RESIDENTIAL ENGINEERING SERVICES, LLC.
 SHOP DRAWINGS/SUBMITTAL REVIEW

STATUS:
APPROVED
 12.10.2020
 REVIEWED BY:
BH
 ENGINEER, RESIDENTIAL ENGINEERING SERVICES, LLC

JOB No.	2542170
DESCRIPTION	Summit - #9 Woodside Ridge
JOB ADDRESS	2005 NW Ashurst Dr.
CITY	Lee's Summit, MO
DESIGNER	Scott Cleverger
DATE	12/11/2020
ROOF TRUSS LAYOUT	
PAGE	
1 of 1

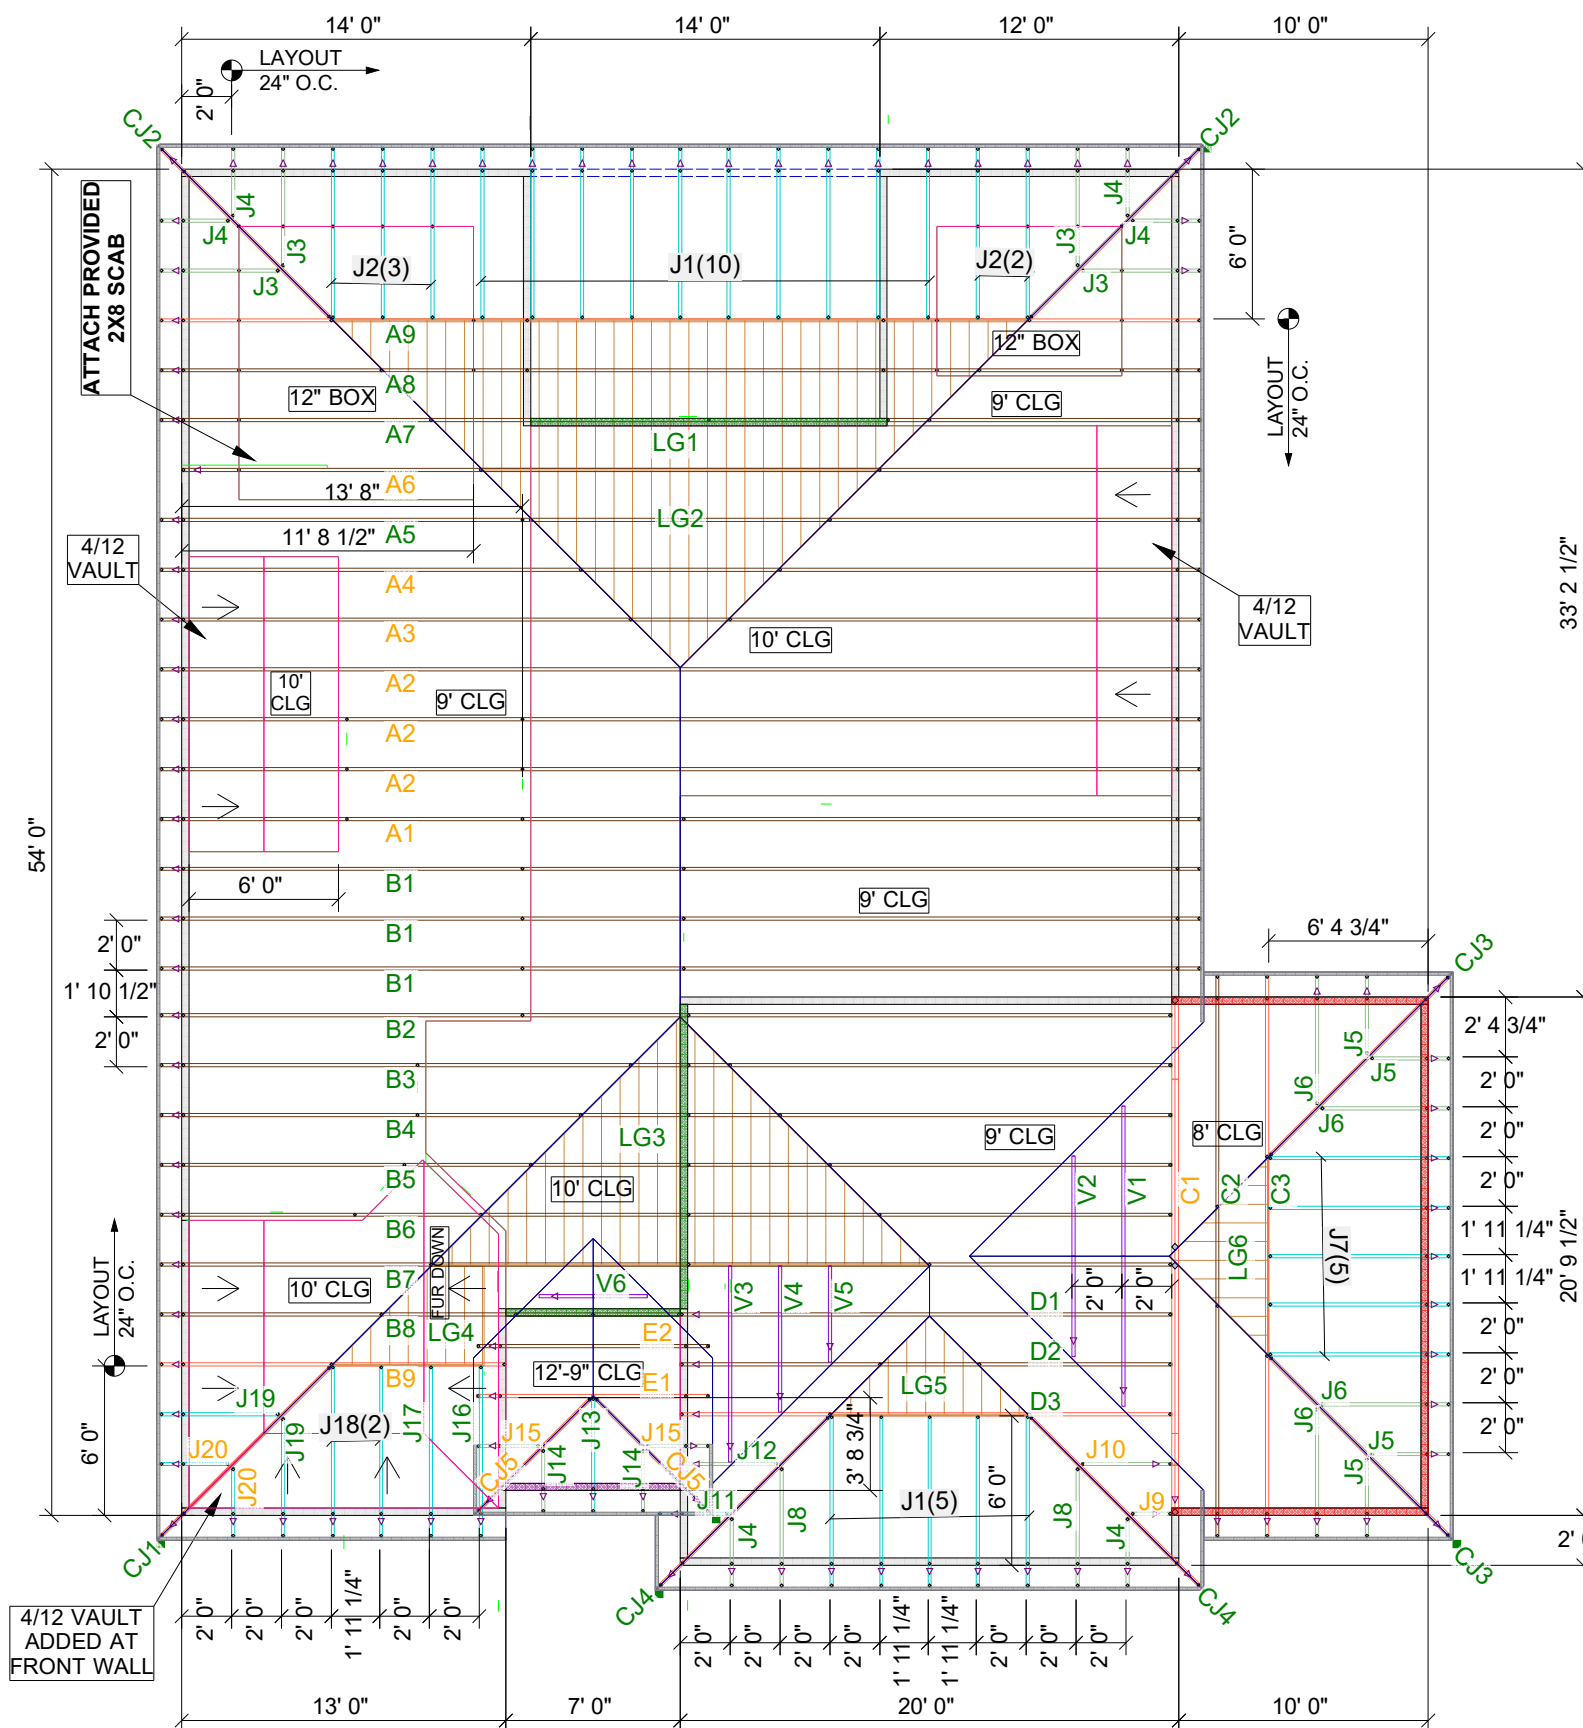
SUBMITTAL WAS REVIEWED FOR DESIGN CONFORMITY AND GENERAL CONFORMANCE TO CONTRACT DOCUMENTS ONLY. THE CONTRACTOR IS RESPONSIBLE FOR CONFIRMING AND CORRELATING DIMENSIONS AT JOBSITE FOR TOLERANCE, CLEARANCE, QUANTITIES, FABRICATION, COORDINATION OF HIS OR HER WORK WITH OTHER TRADES, AND FULL COMPLIANCE WITH CONTRACT DOCUMENTS.
